City of Boise ADA
Assessment

Appendix A-Library! Capitol

10/28/2020

Report #TO20-B001

ID: 1105 **Facility:** Capitol Library

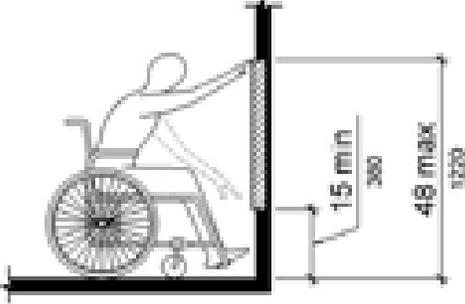
2010 ADA Standards for Accessible Design Codes: §308.2.1
The hangers are outside of the unobstructed forward reach range at 64" above the floor.

Lower the hangers by 16" to meet the accessible reach range of 15" minimum and 48" maximum above the floor. Or add a secondary lower railing located within the accessible reach range.

ID: 2212 **Facility:** Capitol Library

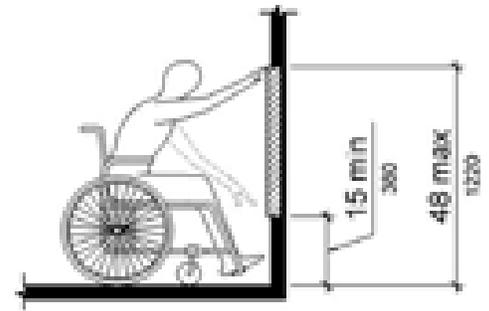
The hook is outside of the unobstructed forward reach range at 63" above the floor.

Lower the hook by 15" to meet the accessible reach range of 48" maximum above the floor.

ID: 1131 **Facility:** Capitol Library

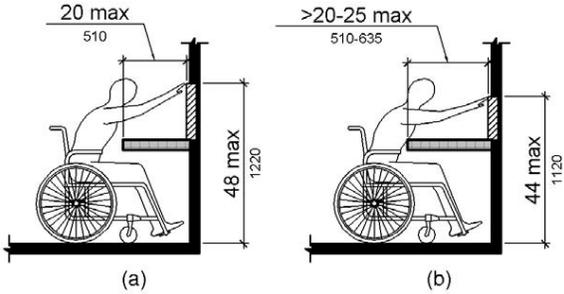
2010 ADA Standards for Accessible Design Codes: §308.2.2
The hooks are outside of the obstructed forward reach range at 64" above the floor.

Lower the hooks by 16" to meet the accessible reach range of 15" minimum and 48" maximum above the floor.

ID: 1146
Facility: Capitol Library

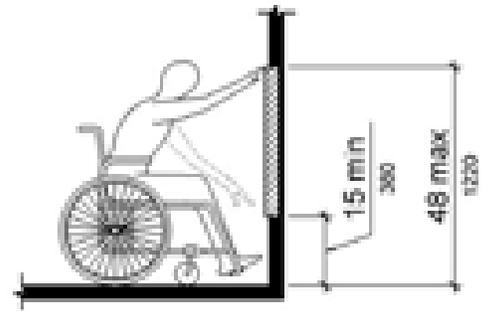
The hooks are outside of the unobstructed forward reach range at 52" above the floor.

Lower the hooks by 4" to meet the accessible reach range of 15" minimum and 48" maximum above the floor.

ID: 1161 **Facility:** Capitol Library

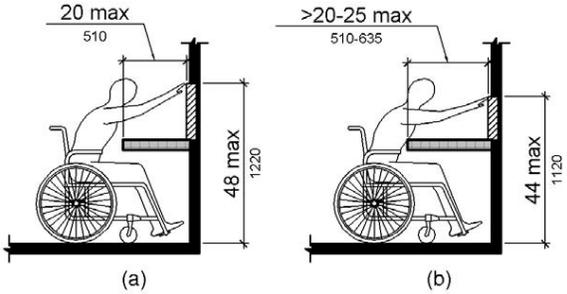
2010 ADA Standards for Accessible Design Codes: §308.2.2
The paper towel dispenser is outside of the obstructed forward reach range at 58" above the floor.

Lower the paper towel dispenser by 10" to meet the accessible reach range of 15" minimum and 48" maximum above the floor.

ID: 1168 **Facility:** Capitol Library

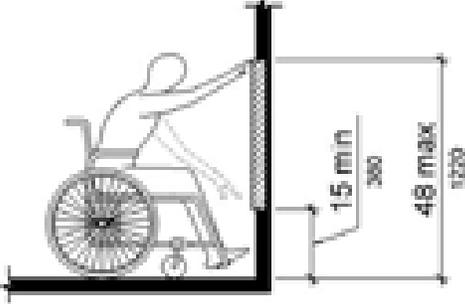
2010 ADA Standards for Accessible Design Codes: §308.2.1
The hook is outside of the unobstructed forward reach range at 69" above the floor.

Lower the hook by 21" to meet the accessible reach range of 15" minimum and 48" maximum above the floor.

ID: 1173 **Facility:** Capitol Library

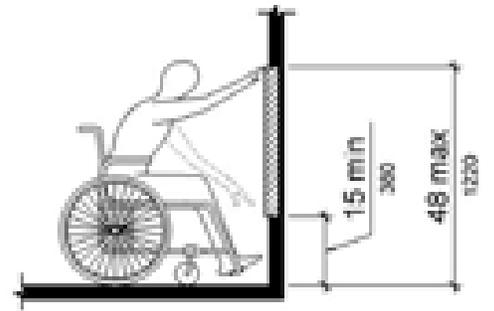
The hook is outside of the unobstructed forward reach range at 50.75" above the floor.

Lower the hook by 2.75" to meet the accessible reach range of 15" minimum and 48" maximum above the floor.

ID: 1181 **Facility:** Capitol Library

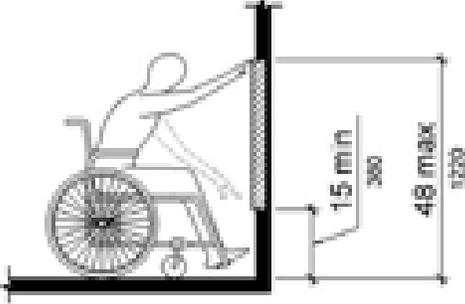
2010 ADA Standards for Accessible Design Codes: §308.2.1
The hooks are outside of the unobstructed forward reach range at 63.5" above the floor.

Lower the hooks by 15.5" or install a secondary lower hook to meet the accessible reach range of 15" minimum and 48" maximum above the floor.

ID: 1188 **Facility:** Capitol Library

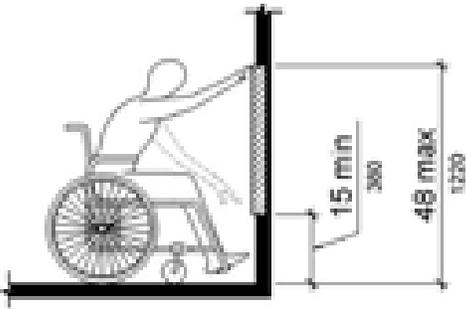
2010 ADA Standards for Accessible Design Codes: §308.2.1
The payment controls on the vending machine are outside of the unobstructed forward reach range at 52" above the floor.

Replace the vending machine with one that has controls located within the accessible reach range of 15" minimum and 48" maximum above the floor.

ID: 1226 **Facility:** Capitol Library

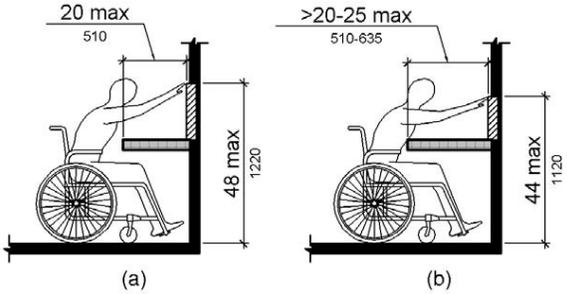
2010 ADA Standards for Accessible Design Codes: §308.2.2
The comments box is outside of the obstructed forward reach range at 58" above the floor.

Lower the comments box by 10" to meet the accessible reach range of 15" minimum and 48" maximum above the floor.

ID: 1245 **Facility:** Capitol Library

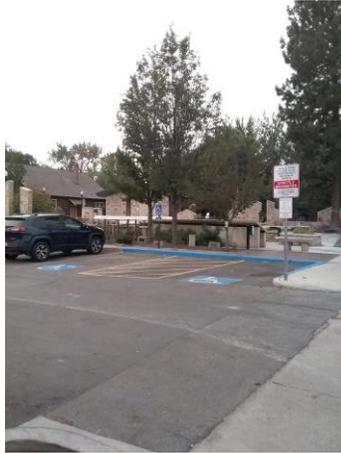
2010 ADA Standards for Accessible Design Codes: §502.6
One parking space is missing the signage identifying the accessible parking spaces. The parking space is located near Idaho Anne Frank Human Rights Memorial.

Install an accessible parking sign at each accessible space at a minimum height of 60" above the ground.

ID: 1249 **Facility:** Capitol Library

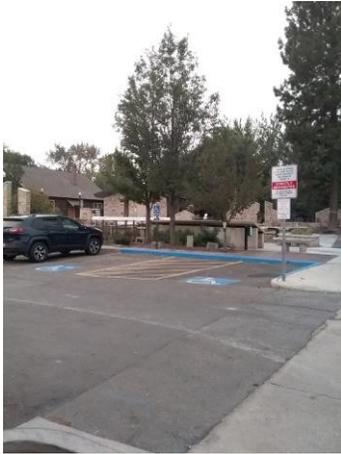
2010 ADA Standards for Accessible Design Codes: §502.6
The accessible parking sign is 56.5" above the ground. The parking space is located by Idaho Anne Frank Human Rights Memorial.

Remount the accessible parking sign at the accessible space at a minimum height of 60" above the ground.

ID: 1079 **Facility:** Capitol Library

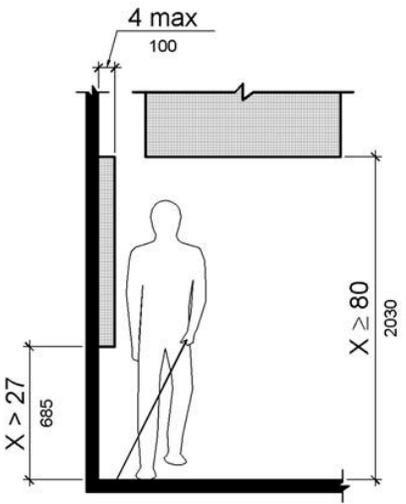
2010 ADA Standards for Accessible Design Codes: §307.2
The shelf protrudes 8" into the circulation space at 28" above the floor.

Lower the shelf by 1" to 27" maximum above the floor, or provide cane detectability by placing an object underneath both ends of the counter.

ID: 1080 **Facility:** Capitol Library

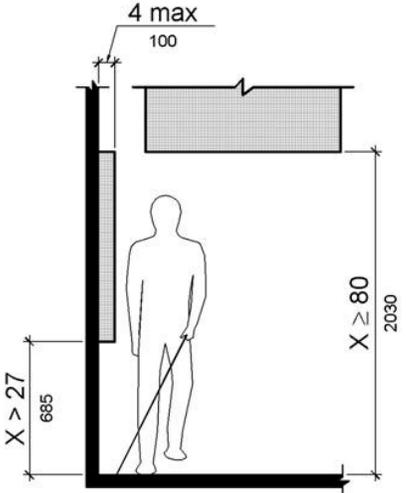
2010 ADA Standards for Accessible Design Codes: §307.2
The charging station protrudes 4.5" into the circulation space at 38" above the floor.

Reduce the protrusion depth to a maximum of 4" by recessing it or provide cane detectability by placing an object underneath.

ID: 1081 **Facility:** Capitol Library

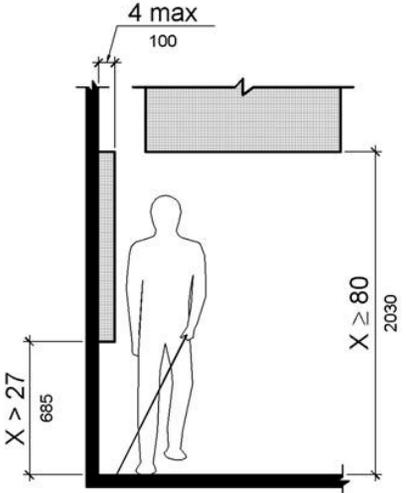
2010 ADA Standards for Accessible Design Codes: §307.2
The fire extinguisher protrudes 6" into the circulation space at 30.5" above the floor.

Recess the fire extinguisher so it protrudes a maximum of 4", lower it so the bottom edge is 27" maximum above the floor, or place a cane-detectable object beneath it.

ID: 1083 **Facility:** Capitol Library

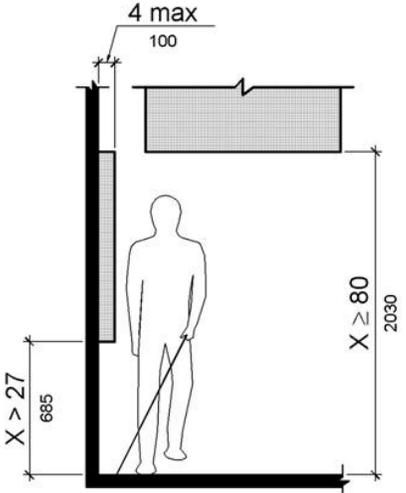
2010 ADA Standards for Accessible Design Codes: §609.3
The toilet paper dispenser is located 4.5" above the side grab bar.

Relocate the toilet paper dispenser so that the bottom edge is at a location that is at least 12" or greater above the grab bar.
Ensure that the center of the toilet paper dispenser is located 7" minimum to 9" maximum in front of the toilet and a maximum height of 48" above the floor.

ID: 1085 **Facility:** Capitol Library

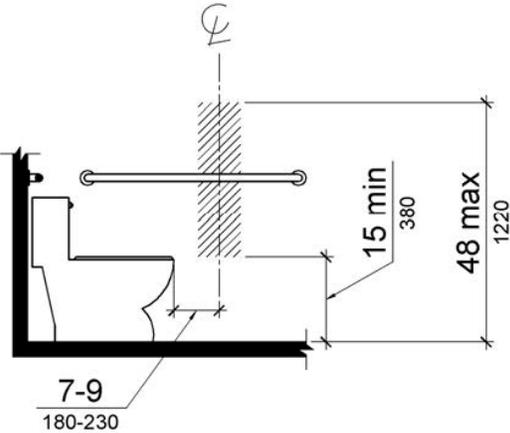
2010 ADA Standards for Accessible Design Codes: §609.3
The toilet seat cover dispenser is located 2.75" above the rear grab bar.

Relocate the toilet seat cover dispenser so that the bottom edge is at a location that is at least 12" or greater above the grab bar. Ensure that the dispenser is at a maximum height of 48" above the floor.

ID: 1092 **Facility:** Capitol Library

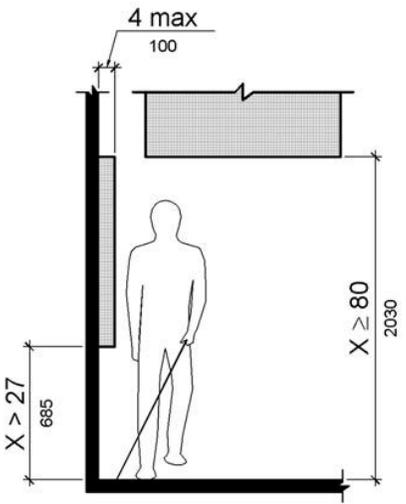
2010 ADA Standards for Accessible Design Codes: §307.2
The dispenser protrudes 5.5" into the circulation space at 31" above the floor.

Recess the dispenser so it protrudes a maximum of 4", lower it so the bottom edge is 27" maximum above the floor, or place a cane-detectable object beneath it.

ID: 1093 **Facility:** Capitol Library

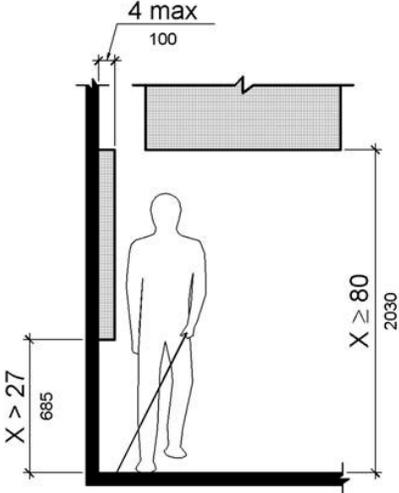
2010 ADA Standards for Accessible Design Codes: §606.5
The pipes under the sink are not covered.

Wrap the pipes beneath the sink with soft protective wrap or plastic.

ID: 1098 **Facility:** Capitol Library

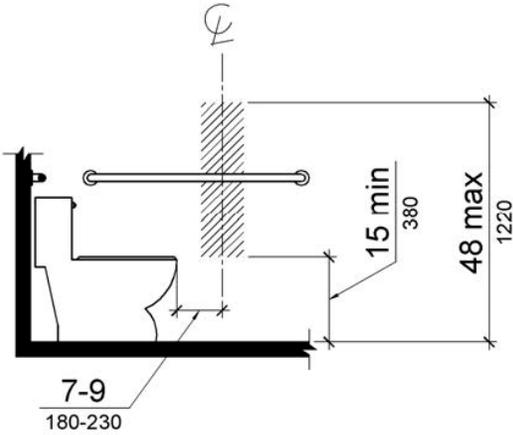
2010 ADA Standards for Accessible Design Codes: §604.7
The toilet paper dispenser is 5" in front of the toilet.

Remount the toilet paper dispenser so that its center is located 7" minimum to 9" maximum in front of the toilet. Ensure that the height is within the accessible reach range of 15" minimum to 48" maximum above the floor.
If mounted above the grab bar, ensure that the bottom edge of the dispenser at least 12" above the grab bar.

ID: **Facility:**
 Capitol Library

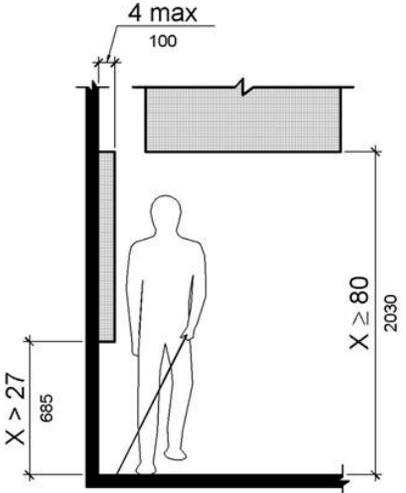
2010 ADA Standards for Accessible Design Codes: §307.2
 The sharps dispenser protrudes 4.75" into the circulation space at 45" above the floor.

Recess the dispenser so it protrudes a maximum of 4", lower it so the bottom edge is 27" maximum above the floor, or place a cane-detectable object beneath it.

ID: 1102 **Facility:** Capitol Library

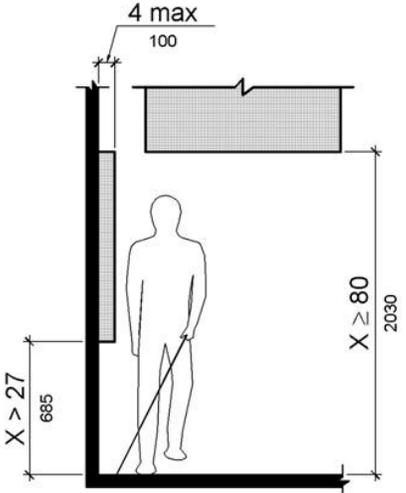
2010 ADA Standards for Accessible Design Codes: §307.2
The dispenser protrudes 5.75" into the circulation space at 30" above the floor.

Recess the dispenser so it protrudes a maximum of 4", lower it so the bottom edge is 27" maximum above the floor, or place a cane-detectable object beneath it.

ID: 1102 **Facility:** Capitol Library

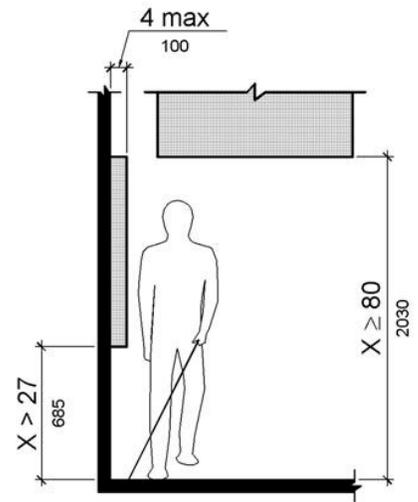
The fire extinguisher protrudes 4.5" into the circulation space at 28.5" above the floor.

Recess the fire extinguisher so it protrudes a maximum of 4", lower it so the bottom edge is 27" maximum above the floor, or place a cane-detectable object beneath it.

ID: 1103 **Facility:** Capitol Library

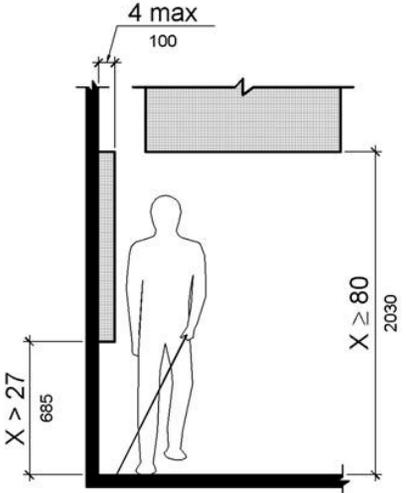
2010 ADA Standards for Accessible Design Codes: §307.2
The shelf protrudes 6.5" into the circulation space at 45" above the floor.

Reduce the shelf protrusion depth to a maximum of 4" or lower it so the bottom edge is 27" maximum above the floor, or remove it.

ID: 1106 **Facility:** Capitol Library

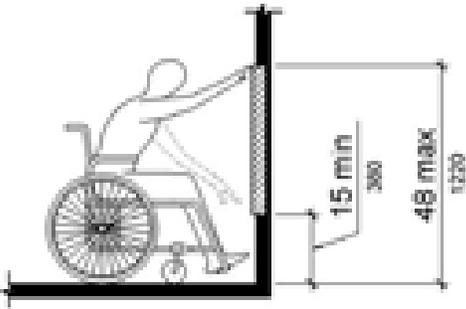
2010 ADA Standards for Accessible Design Codes: §307.2, §308.2.1
The paper towel dispenser is outside of the unobstructed forward reach range at 53" above the floor. The paper towel dispenser protrudes 9" into the circulation space at 53" above the floor.

Lower the paper towel dispenser by 5" to meet the accessible reach range of 15" minimum and 48" maximum above the floor.
Recess the dispenser so it protrudes a maximum of 4", lower it so the bottom edge is 27" maximum above the floor, or place a cane-detectable object beneath it.

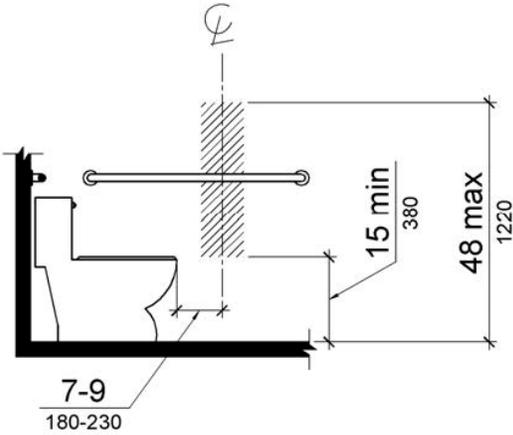
2010 ADA Standards for Accessible Design Codes: §604.7
The toilet paper dispenser lines up with the rim of the toilet which is not an accessible position.

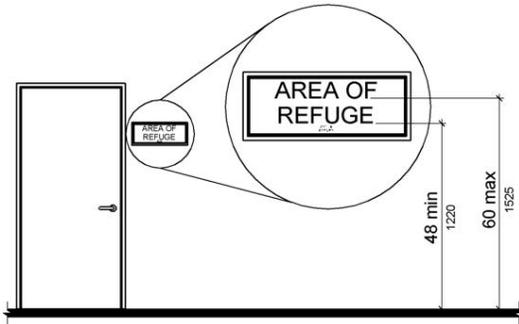
2010 ADA Standards for Accessible Design Codes: §703.4
The tactile sign identifying the room is not in the correct location.

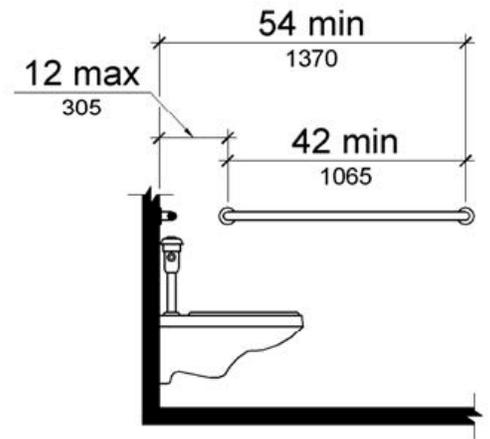
The side grab bar is 30" long.

Replace the side grab bar with one that is a minimum of 42" long minimum, located 12" maximum from the rear wall and extending 54" from the rear wall.

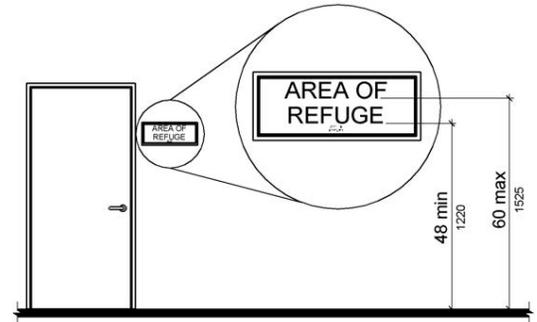
There are no tactile signs identifying 110 permanent rooms.
